DESCRIPTIVE REPORT

Type of Survey HYDROGRAPHIC
Field No. RA-40-06-09
Registry No. H12078

State Alaska
General Locality Pavlof Islands
Sublocality North of Wosnesenski Island

Revisions and Corrections Compiled During Office Processing and Certification

Figure 2: Sound Speed Artifacts From RA-3 on DN190

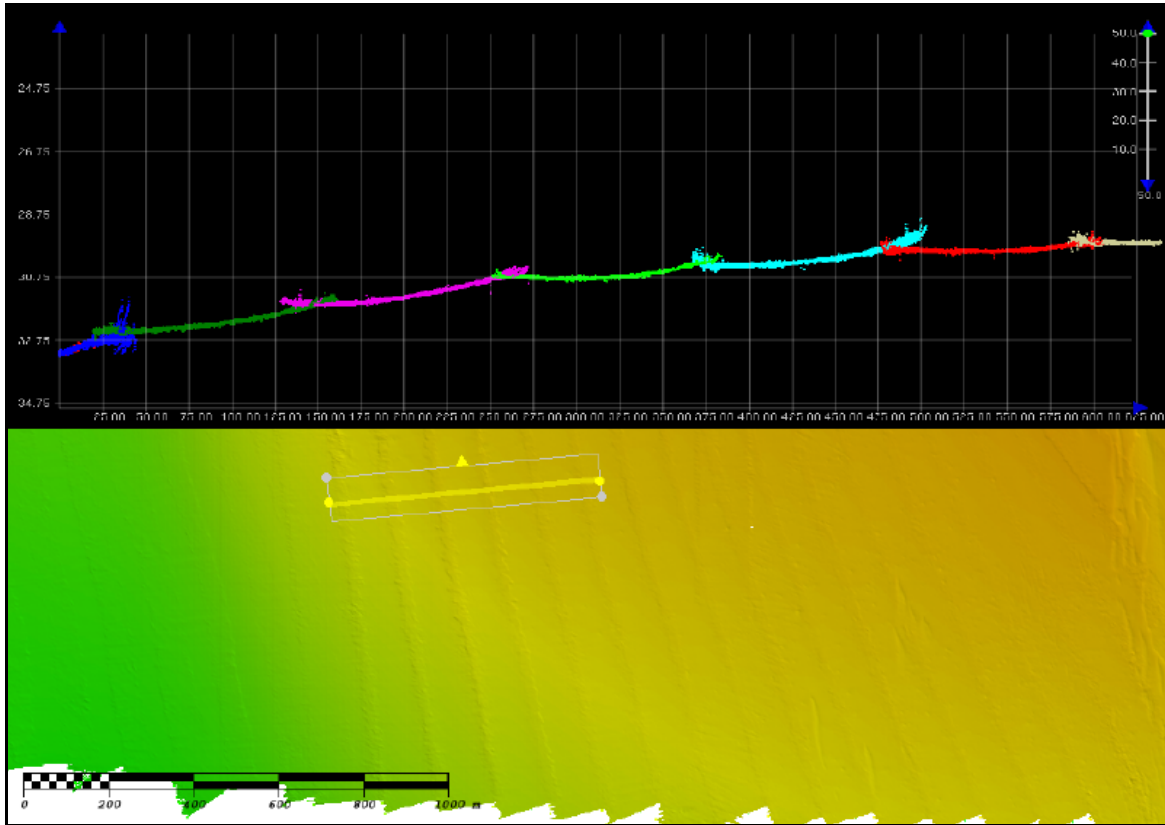
Despite the best efforts of the Hydrographer to conduct sufficient sound velocity casts distributed both spatially and temporally, sound velocity errors were still noticeable in several regions. Lines run on DN179 and DN190 by vessel 2803 (RA-3), and DN194 by 2802 (RA-5) exhibited the characteristic "smiles" indicative of inaccurate sound velocity corrections (Figure 2). In most cases the errors remained within IHO specifications. In the areas that

exceeded IHO standards, the Hydrographer rejected soundings from the outermost beams that exceeded the IHO specifications.⁹

- ⁷ Concur.
- ⁸ Concur.
- ⁹ After rejecting the outer beams on data exhibiting sound speed errors, the remaining data is adequate to supersede charted data in the common area.

Figure 4: Water column noise from vessel 1101 (RA-1) on DN217

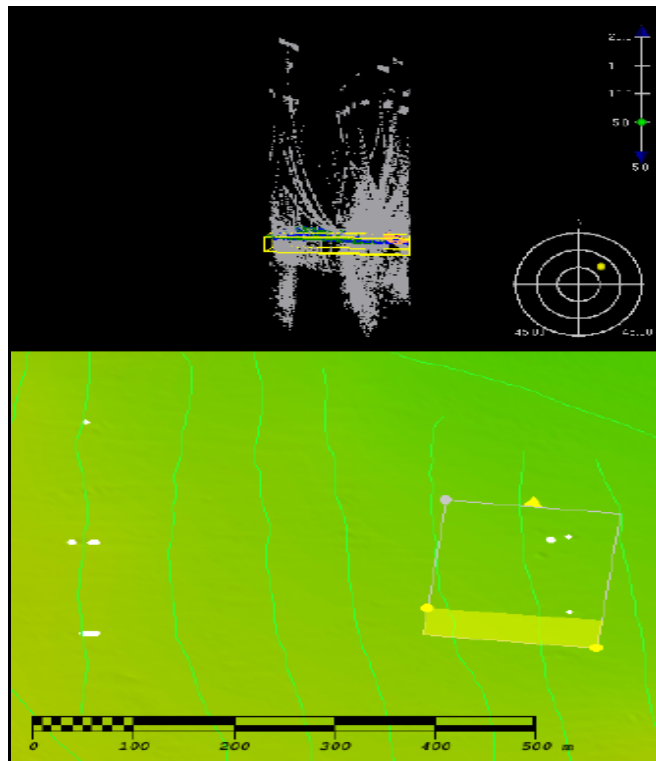
Data acquired on DN216 and DN217 by all vessels exhibited extensive noise (Figure 4). Survey operations during these days were severely hampered by inclement weather, mainly high winds and choppy sea state. As a result, numerous small holidays occur in these data, as well as significantly sparser density in soundings which caused CUBE to create “lumpy” surfaces. The Hydrographer manually rejected noisy data affecting the surface, which often resulted in holidays.¹²

- ¹¹ Concur.
- ¹² After cleaning the noisy data, the remaining data is adequate to supersede charted data in the common area.
- ¹³ Concur. The data is adequate to supersede charted data in the common area.

Figure 5: Vertical Offset from RA-5 on DN170

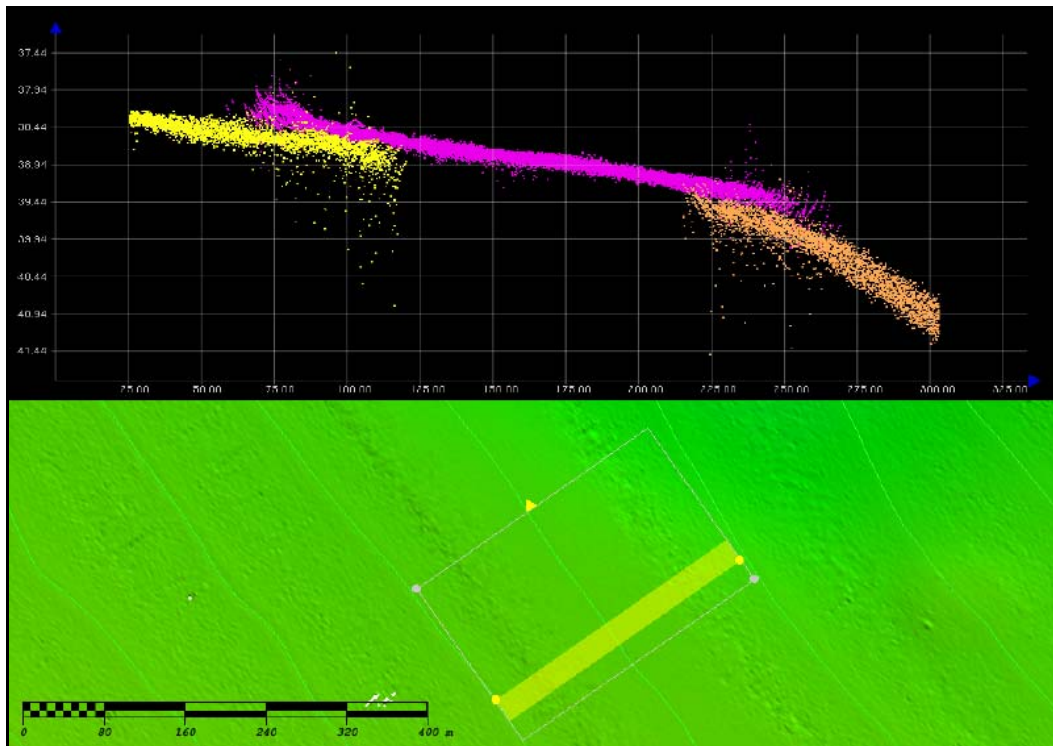
Minor vertical offsets were present with data acquired on DN170 where it junctions with data acquired on other days (Figure 5). Generally agreement was 0.1 to 0.2 meters, with a maximum of 0.25 meters in 38 meters of depth, falling within IHO Order 1 specifications.¹⁴

- ¹⁴ Concur. The data is adequate to supersede charted data in the common area.
- ¹⁵ Concur with clarification. Chart foul areas as depicted in the HCell.

Figure 9: Shift in 20 fathom contour North of Wosnesenski Island

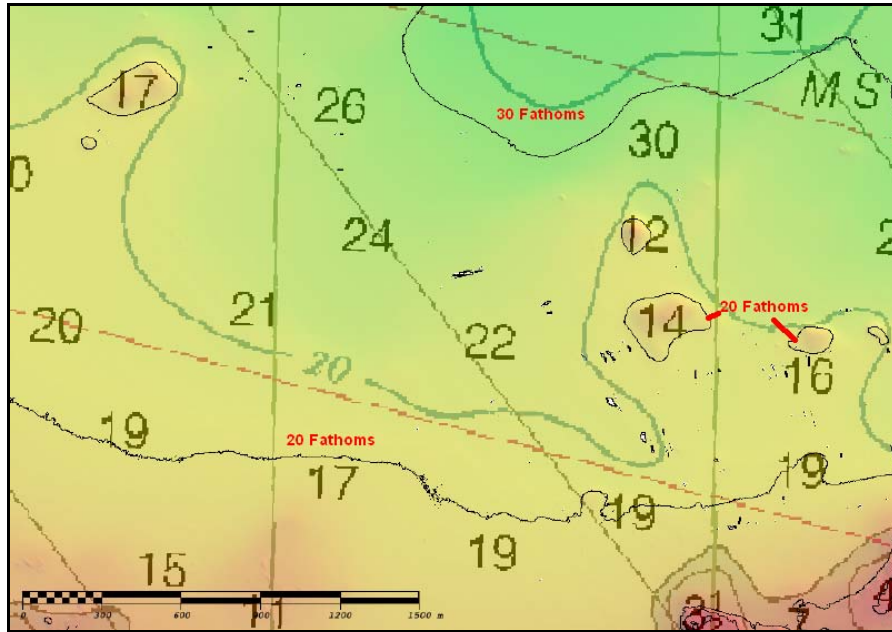
In general, contour lines on charts 16551 and 16549 were charted with reasonable accuracy. The only major change found was that the 20 fathom contour to the North of Wosnesenski Island has migrated considerably inshore, with only a few isolated shoal soundings remaining (Figure 9).²⁴

- ²⁰ See attached Tide Note dated September 4, 2009.
- ²¹ Concur.
- ²² Concur.
- ²³ Concur. Chart depths as depicted in the HCell.
- ²⁴ Update charted contours with new survey data.

Figure 10: Mischarted shoals

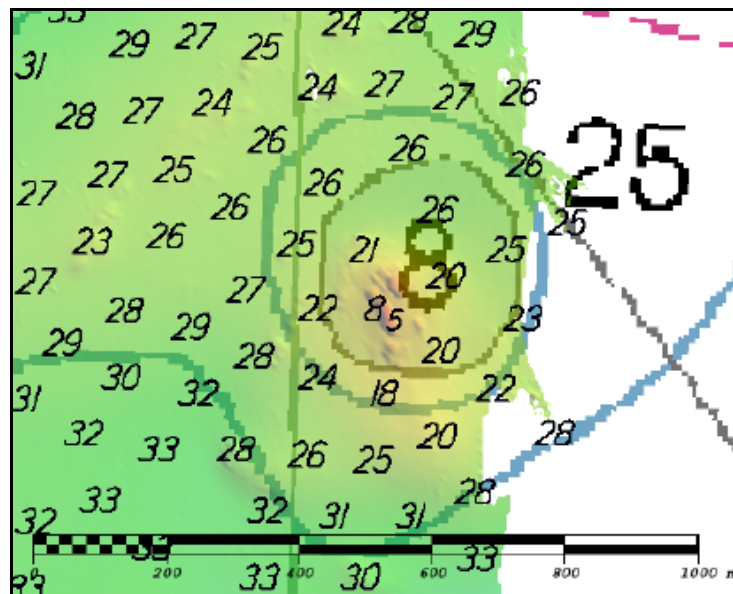
There were very few survey soundings in H12078 that were in excess of 1 fathom deeper than charted depths. In all areas where this was true, *Rainier* achieved complete multibeam coverage. In almost all cases depths were consistent with soundings in the area, but appear to be translated horizontally (Figure 10). This generally occurred to the North of Wosnesenski Island, where depths agreed with soundings within one fathom, but appeared to be shifted horizontally by 50 to 150 meters.²⁵

- ²⁵ Concur. Chart depths as depicted in the HCell.
- ²⁶ Update depths and features as depicted in the HCell. Update charted coastline based on the latest available GC shoreline.

Figure 11: Shoreline and contour discrepancies between Charts 16551 and 16549 (Overlay)

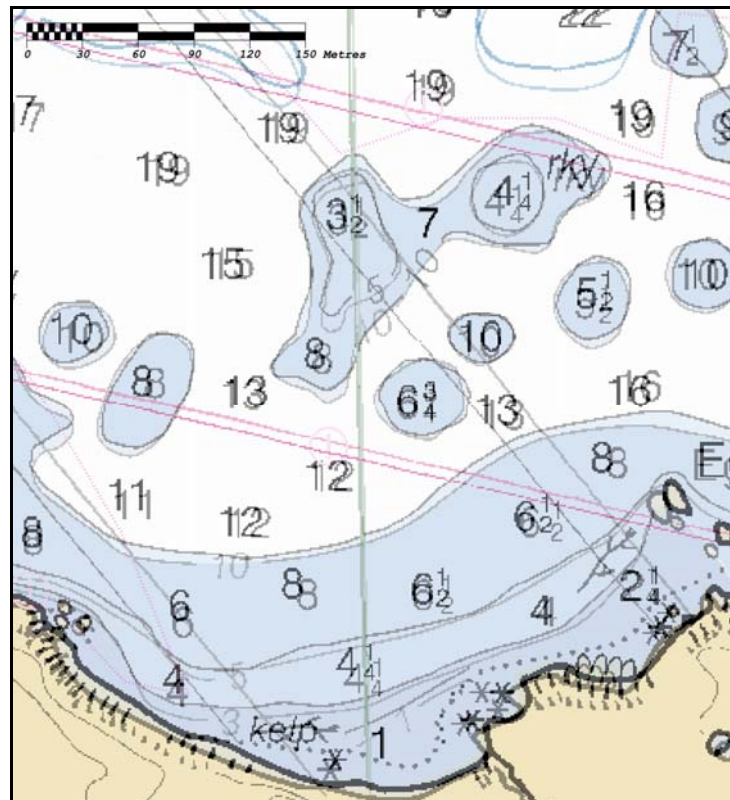
Discrepancies between the charted shoreline of 16549 and 16551 were noticed as indicated in Figure 11. The shoreline depicted on chart 16551 agrees reasonably well with the composite source shoreline as provided with the project; and minor offsets are apparent between composite source and the shoreline of chart 16549. A more detailed high water line and additional rocks and ledges are also found on chart 16551 when compared to chart 16549. Even though both charts are of the same scale, the shoreline of chart 16551 appears to have been compiled at a higher resolution than that of chart 16549. The charted 16551 shoreline agrees much more closely with shoreline observed in the field in the near shore areas of Wosnesenski Islands.²⁶

Figure 12: Danger area on Chart 16551 (Left) mischarted as a MLW line on Chart 16549 (Right)

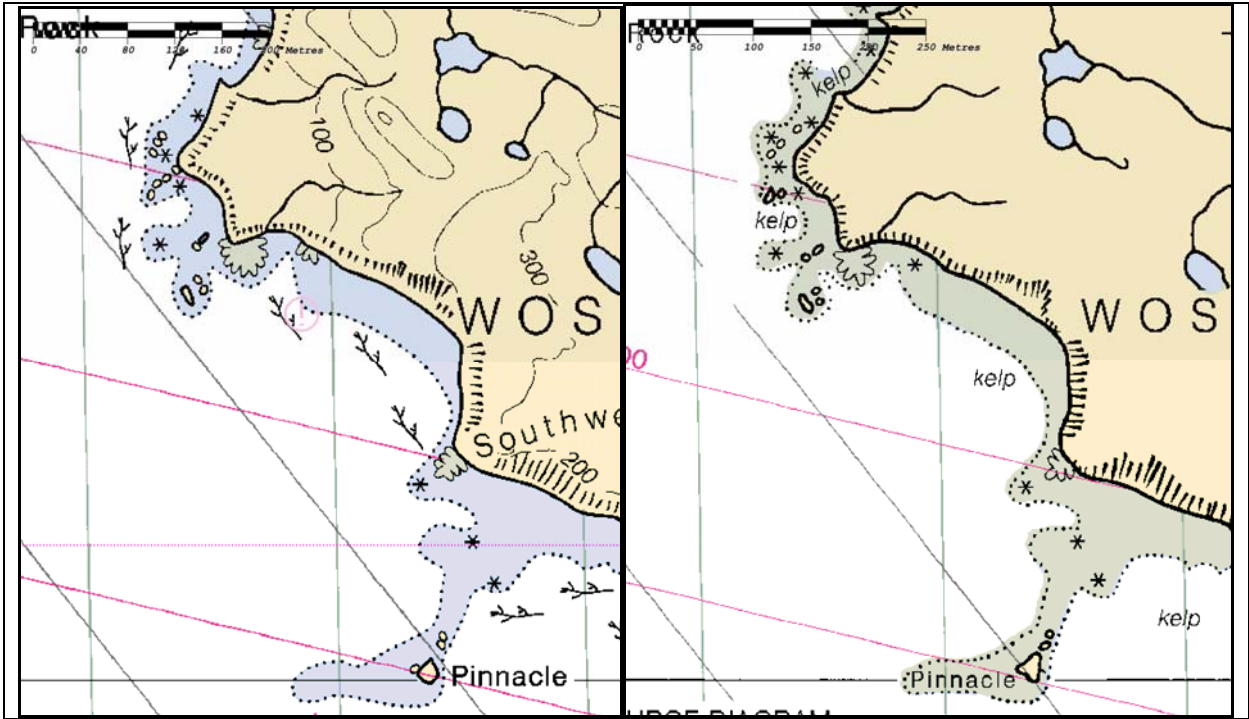
The dotted danger line on chart 16549 is charted incorrectly. The area between danger line and mean high water (MHW) is tinted green, instead of blue. The contrast between charts 16549 and 16551 is shown below in Figure 12. The Hydrographer recommends adjusting the tint inshore of the charted danger lines on chart 16549 to blue.²⁷

- ²⁷ Concur with clarification. Recommend that chart 16549 be updated based the appearance of 16551 and update foul areas as depicted in the HCell. Update charted coastline based on the latest available GC shoreline.

Figure 13: Uncharted wreck in H12078

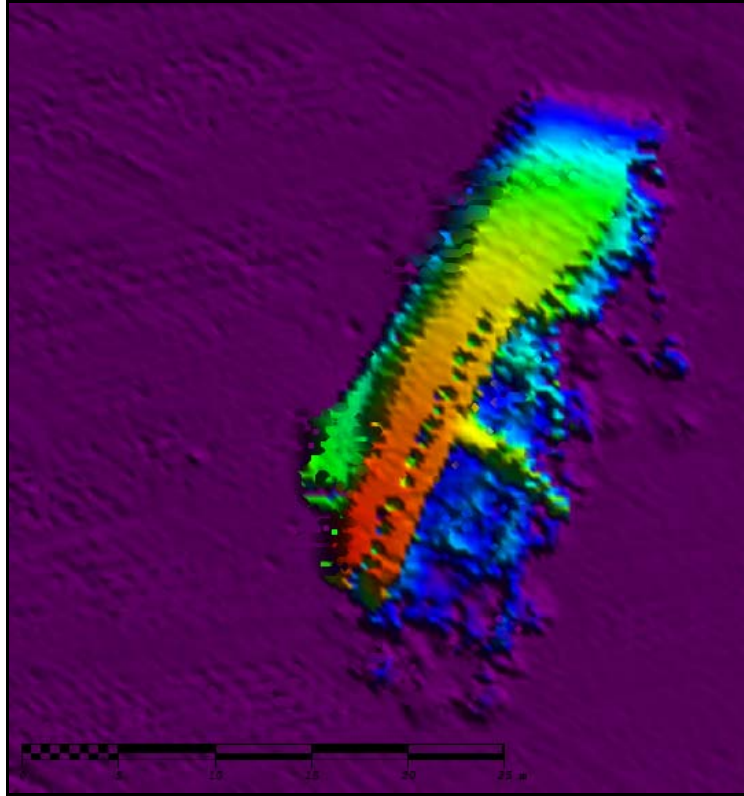
A wrecked vessel was found in previously uncharted waters in 19 meters (10.4 fathoms) of depth at location 55° 15' 04.24" N 161° 29' 43.71" W (Figure 13). The wrecked vessel appears to be a crab boat laden with crab pots lying on her starboard side, measuring approx 30 meters in length and sitting 7 meters higher than the sea floor. The Hydrographer is confident that the least depth was acquired and recommends charting as a wreck as indicated in the Final Features File included in Caris Notebook digital data.³⁰

- ²⁸ Concur.
- ²⁹ Concur.
- ³⁰ Concur with clarification. The compiler recommends that the wreck be added to the AWOIS database.
- ³¹ All six DTONs have been applied to the charts and all are included in the HCell.

Figure 14: H12078 Cable Area

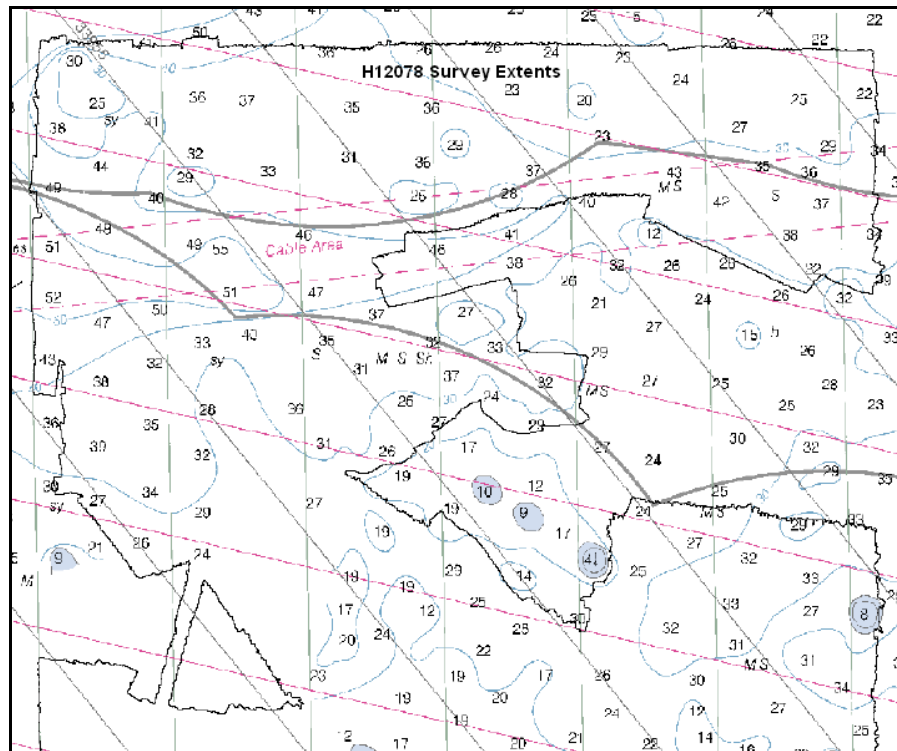
Survey H12078 includes one charted cable areas, as shown in Figure 14. No indication of cables was present in the data, however due to time constraints full coverage was not acquired over the cable area located within the sheet limits. The Hydrographer recommends retaining the cable area as charted.³⁸

³⁸ Concur. The cable area has been blue noted to be retained.

Figure 1.5.1

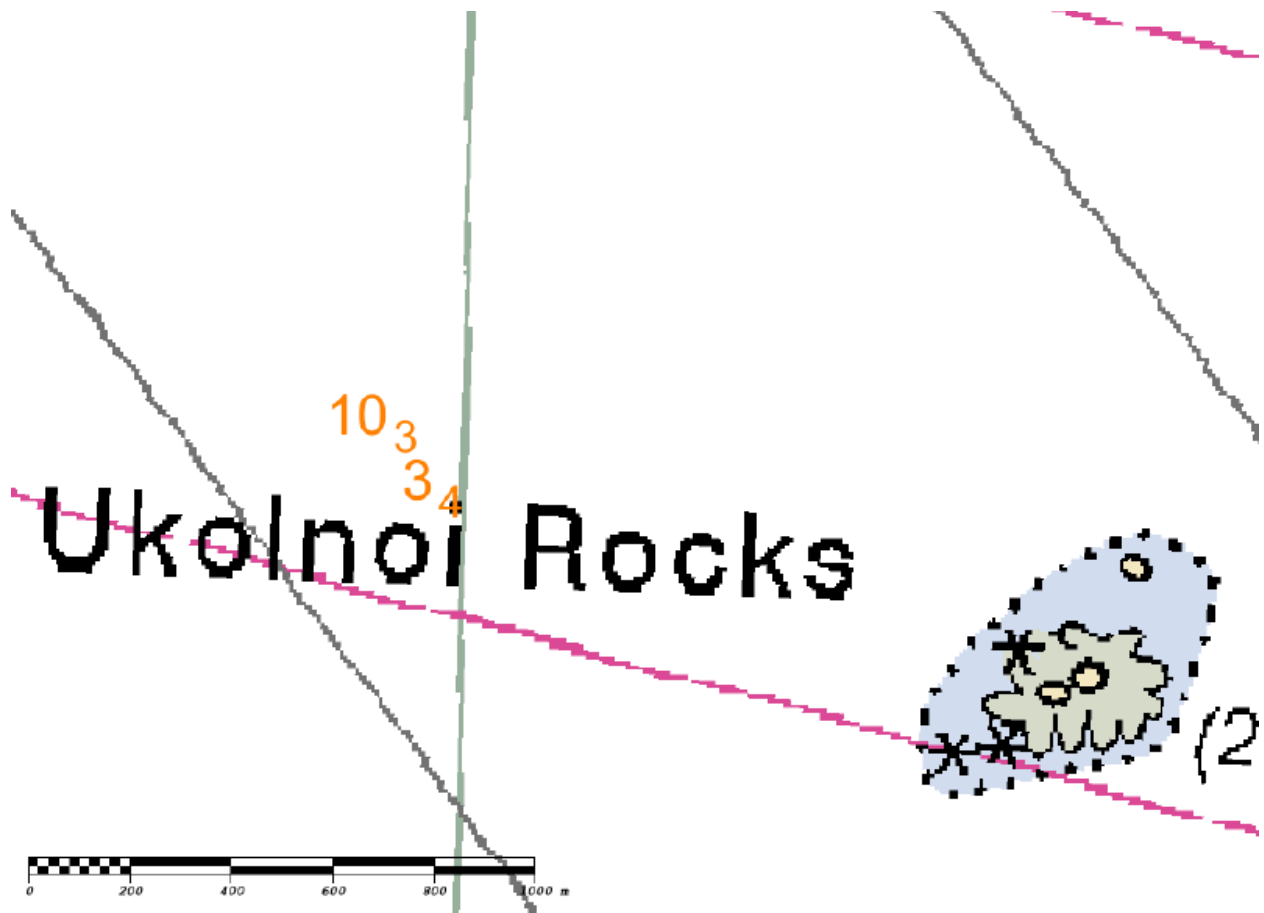
It was noted after submission that the DTON labeled “1.5” of report 2/17/2010 was incorrectly selected; a 10.5 fathom sounding was selected instead of the intended 3.5 fathom sounding.³³ The correct sounding was submitted as a DTON on February 19, 2010 under a separate report and is included in Appendix I.³⁴

- ³² See attached DTON report.
- ³³ The 3.5 fathom sounding has been applied to the charts and is included in the HCell.
- ³⁴ See attached DTON report.
- ³⁵ Concur with clarification. The submitted hob files were used in the compilation of HCell H12078. During compilation, some modifications were made to accommodate chart scale. Chart features as depicted in the HCell.
